TECHNICAL INFORMATION

Loose Starter Cable Connection

No: 86/04/00/NAS
Ref: 86/08/01/NAS
Issue: 2
Date: 07/27/01

Figure 1

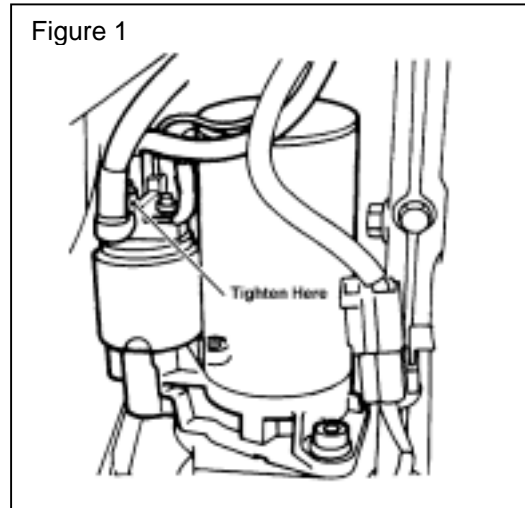
The primary electrical connection between the starter and the battery may not be adequately tightened on vehicles exhibiting these symptoms. A low torque condition will not provide a solid electrical connection.

1. Disconnect battery ground terminal.
2. Slacken and remove the battery-lead-to-starter-solenoid-securing nut at the starter solenoid.
3. Clean all connection surfaces.
4. Install a star washer on the solenoid stud.
5. Install and tighten the nut to **18 Nm (13 lbf.in.)**. (Figure 1)
6. Clean and install battery ground terminal.
7. Start vehicle to verify repair.
